REVISION OF SECTION C  
67 OF CONTRACT DOCUMENTS  
DATED OCT. 1977

75th STREET BRIDGE	
BOULDER, COLORADO URBAN DRAINAGE AND FLOOD CONTROL DISTRICT	
REVISION OF SOUTH ABUTMENT AND ITS EAST WING WALL	
PROJECT NO. 772-74.1	WRIGHT-MCLAUGHLIN ENGINEERS 2420 ALCOTT ST. DENVER, COLO. 80211
DESIGN PB	DATE MARCH 22, 1978
DETAIL PB	DRAWING NO. R-1
CHECK PB

REVISED SECTION  
SOUTH ABUTMENT C  
67  
3/8" = 1'-0"

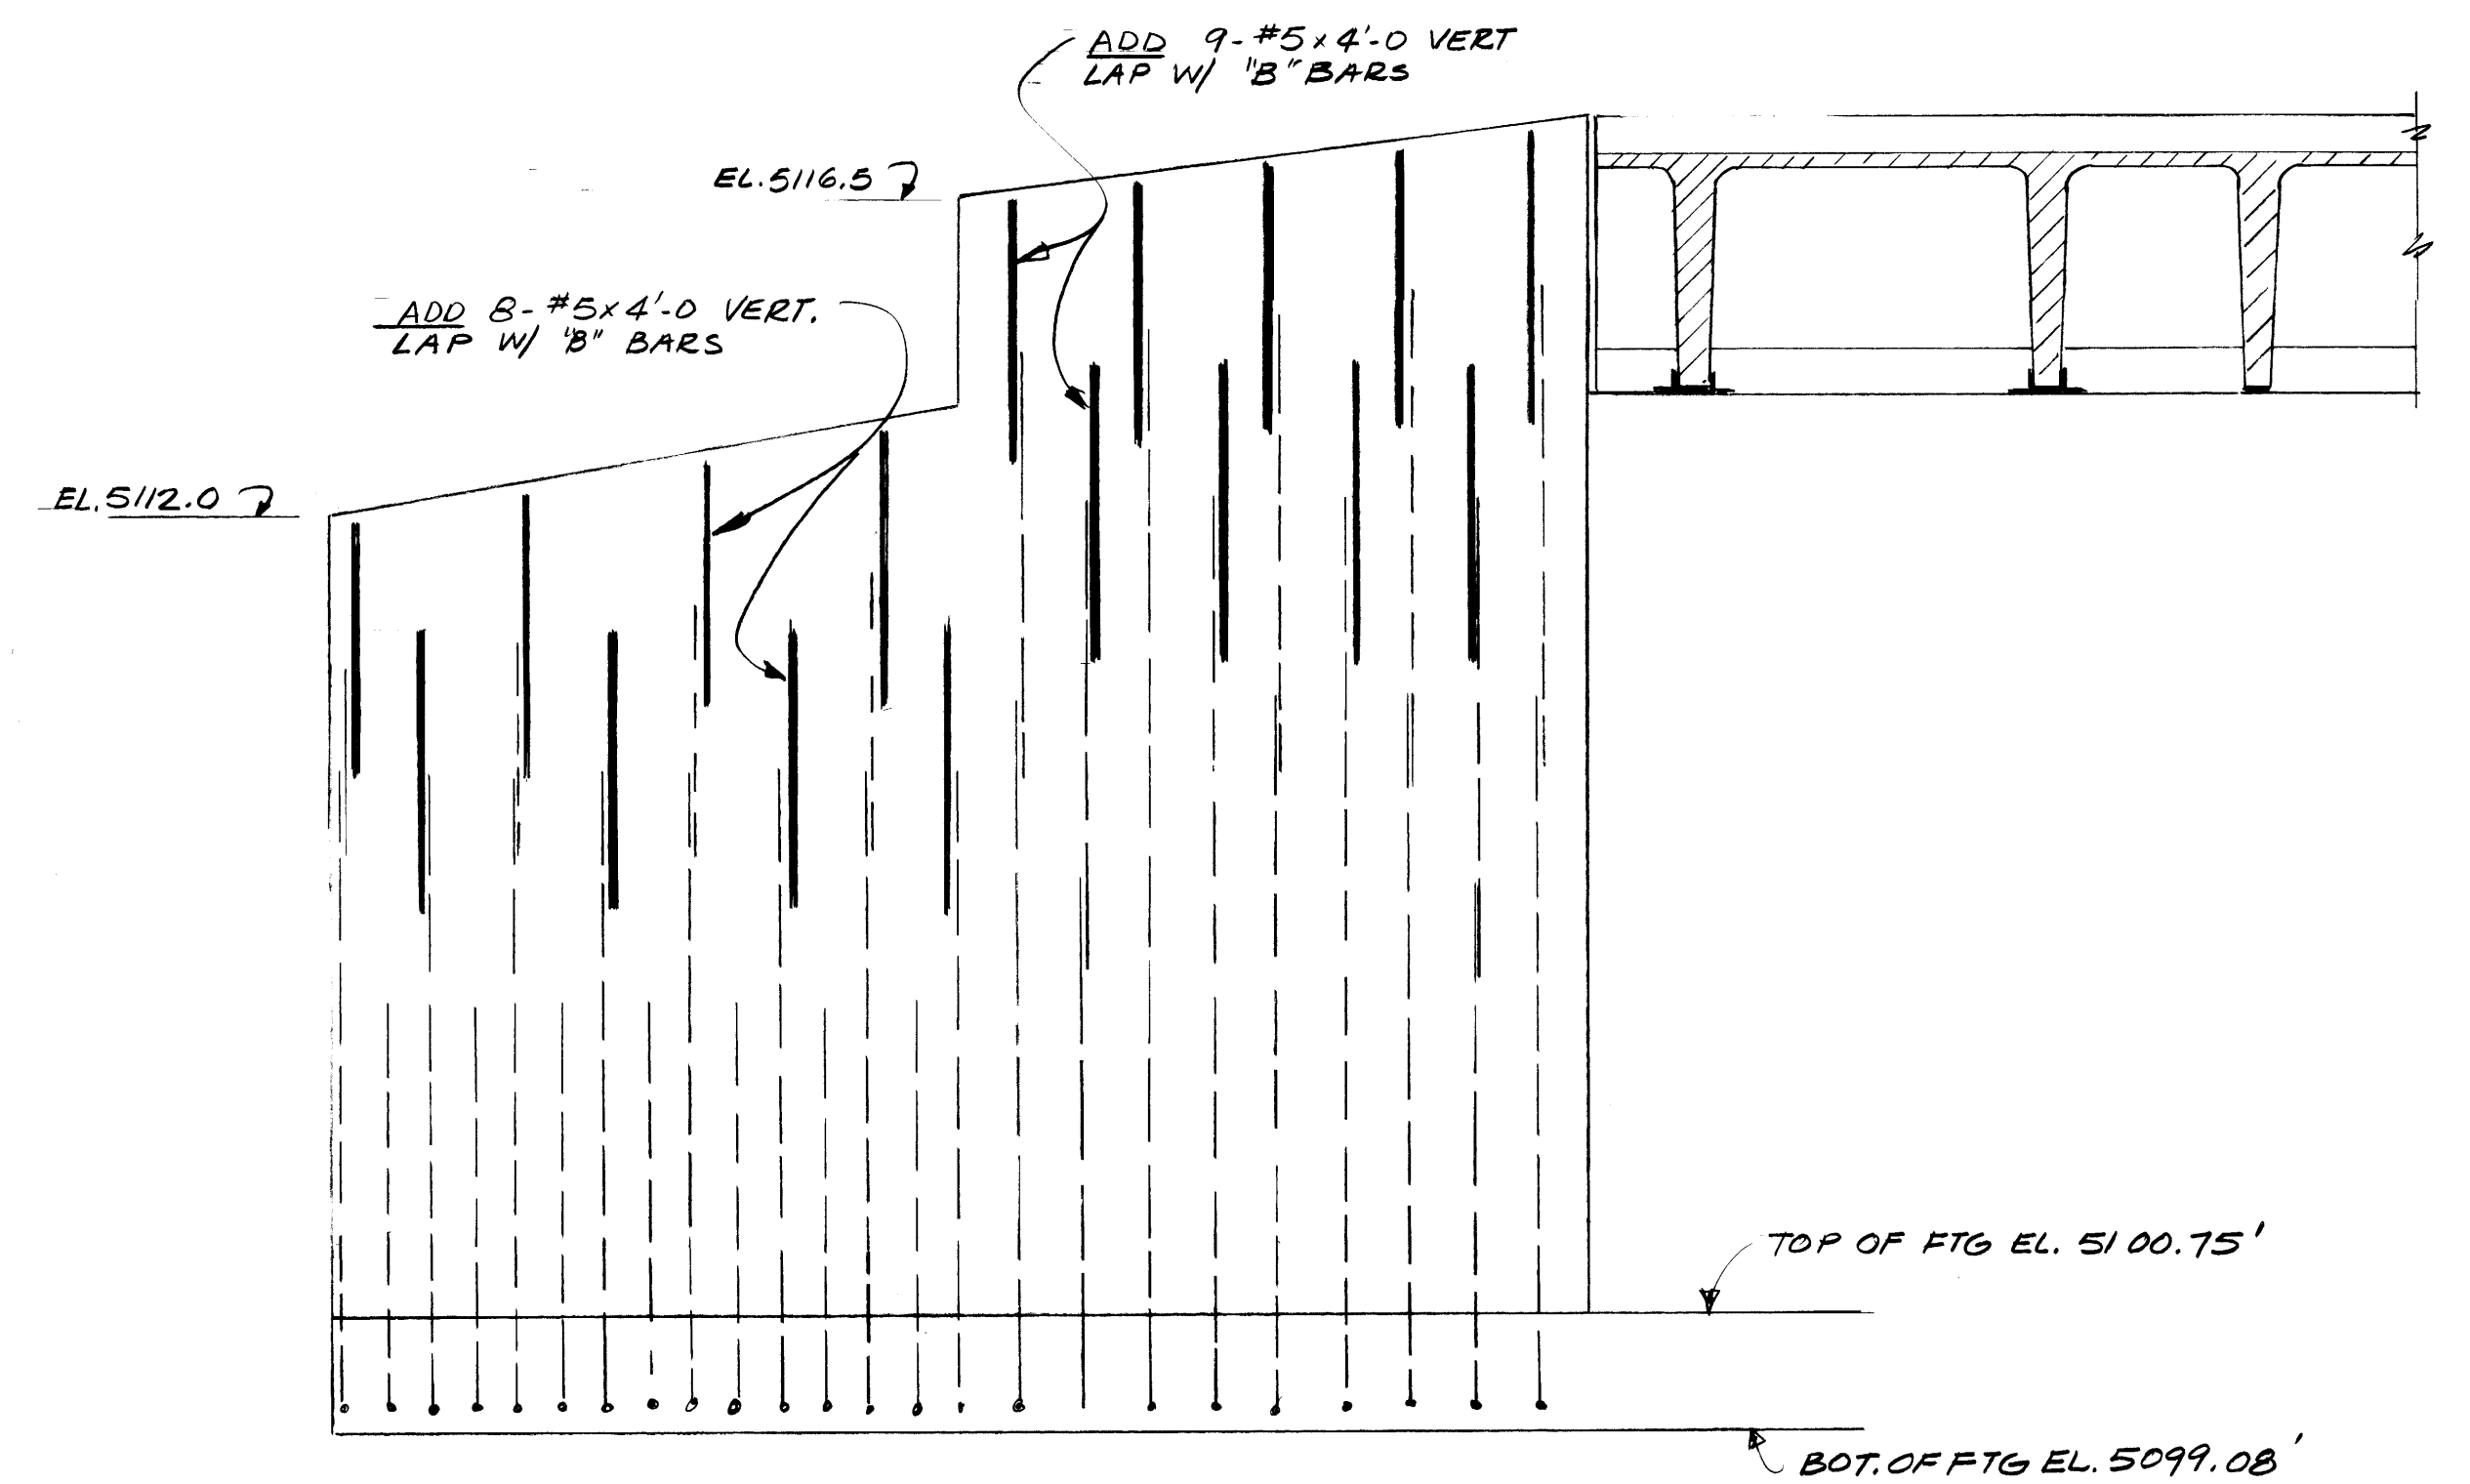
1. CHANGE OF TOP & BOTTOM FOOTING ELEVATION
2. THIS DRAWING TO BE USED ONLY FOR THE ADDITIONAL REINFORCING STEEL REQUIRED DUE TO THE CHANGE IN HEIGHT OF THE ABUTMENT WALL.
3. NOTE WELL! WALL THICKNESS OF ABUTMENT WALL TO BE 2'-4"
4. CONTRACT DOCUMENT SPECIFICATIONS, DATED OCT, 1977, APPLY TO THIS REVISION
